REVIEWER COMMENTS

Reply to reviewers of manuscript
NCOMMS-21-10540:

Solar energy and regional coordination
as a feasible alternative to
large hydropower in Southeast Asia

Figure 1: Peak demand in Thailand (upper panel) and air temperature (lower panel) for the year 2016. The air temperature is measured at Bangna station, near Bangkok. The shaded area illustrates the range of variability across the years 2007-2019.

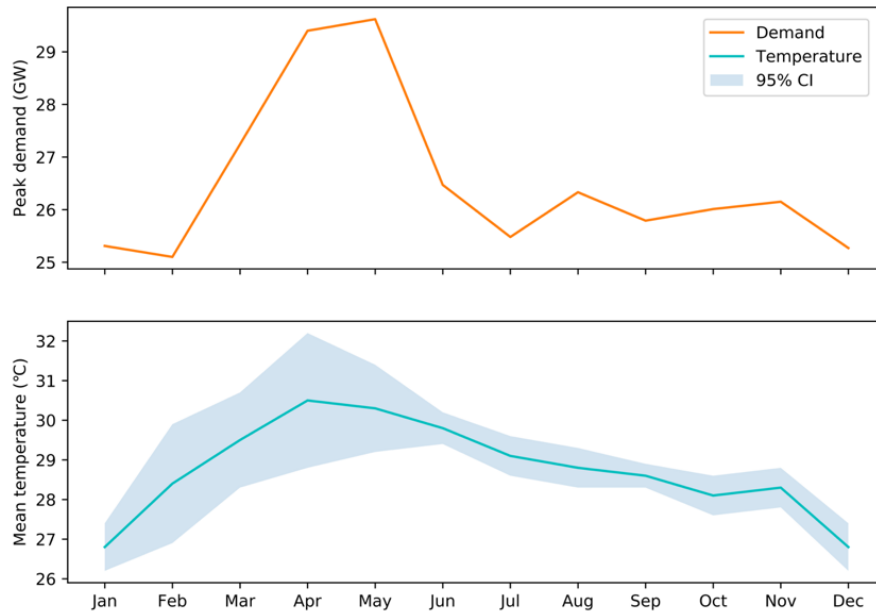
I also wonder whether the model has an established daily profile of demand, as opposed to developing a variable profile via a stochastic approach, perhaps actuated by temperature. I feel like the latter would be needed to evaluate system performance relative to the very high (six sigma) supply reliability that is sought in highly developed economies (or is a different standard applied here?). Also, is there any consideration of spatial correlations in demand highs/lows as a result of covariance in temperature/weather conditions across the region?

As mentioned in the answer to the previous question, the demand profile is a generic one that reflects weekday/weekend and peak/off-peak variations, monthly peak demand for each province, and yearly total demand per country. The demand profile is not explicitly temperature-dependent, but intra-annual temperature variations are implicitly reflected in the monthly peak demand of each province (the higher the temperature, the higher the peak because of air-conditioning). As shown in Figure 1 for the case of Thailand, the demand tends

to increase in the pre-monsoon months (which are drier and slightly warmer) and then decrease during the monsoon period.
